Access Compliance Report

Public Rights-of-Way

Intersection ID: 47108	Main Street: FRANK_LITTLE_CT	Cross Street: ERNEST_RUSSELL_CT	Location: SW
ADA ID: AB67D9E71271	Ramp Type: BlendTrans1	Initial Pass/Fail: Pass	Overall Compliance: No
		Severity Score: 0.25

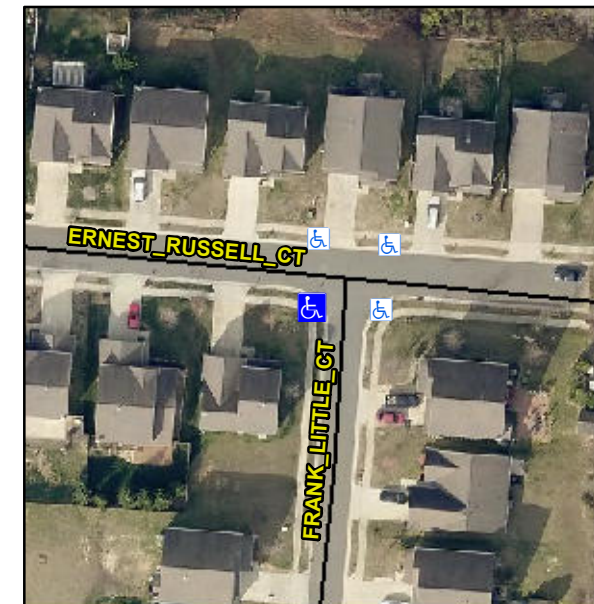
Not Found, R304.5.3, R304.2.1, R304.2.2-Perp, R304.3.2-Para

Compliance	Description	Data	Compliance	Description	Data
N/A	Ramp Length (in)	46.0	Yes	BlendTrans Slope (%)	3.8
Yes	Ramp Width (in)	48.0	No	BlendTrans XSlope (%)	3.0
N/A	Flare Type LT	Sloped	N/A	Flare Type RT	Sloped
N/A	Flare Slope LT (%)	3.3	N/A	Flare Slope RT (%)	7.2
N/A	Flare Traversable LT?	No	N/A	Flare Traversable RT?	No
No	Landing Length (in)	47.0	Yes	DWS Provided?	Yes
Yes	Landing Width (in)	77.0	Yes	DWS Contrast?	Yes
No	Landing Slope (%)	2.8	Yes	DWS Length (in)	24.0
No	Landing X Slope (%)	2.1	Yes	DWS Full Width?	Yes
N/A	Landing Curb? (Y/N)	No	Yes	DWS Offset (in)	2.0
N/A	Shared Landing?	No			
Yes	Gutter Ponding?	No	Yes	Gutter Slope (%)	2.8
Yes	Gutter Lip Ht (in)	0.0	No	Gutter X Slope (%)	2.5
N/A	Painted X Walk1?	No	N/A	Painted X Walk2?	No
	X Walk 1 Direction	To E		X Walk 2 Direction	To N
	X Walk 1 Width (in)	N/A		X Walk 2 Width (in)	N/A
	X Walk 1 Slope (%)	1.8		X Walk 2 Slope (%)	0.5
	X Walk 1 X Slope (%)	0.4		X Walk 2 X Slope (%)	2.3

N/A	Ramp inside XWalk1?	N/A	N/A	Ramp inside XWalk2?	N/A
	Road Slope (%)	2.5		Clear Space?	Yes
	Road X Slope (%)	3.7	N/A	Clear Space to XWalk (in)	N/A
Yes	Any Obstructions?	No	Yes	Storm Grate/Utility Hazard?	No
	Obstruction Type			Storm Grate/Utility Type	
		N/A			N/A
			Yes	Surface Condition? (G/P)	Good
			No	Curb Slope (%)	8.4

Remove & Replace Curb Ramp With Two New Directional Ramps or Equivalent. Remove & Replace Gutter.
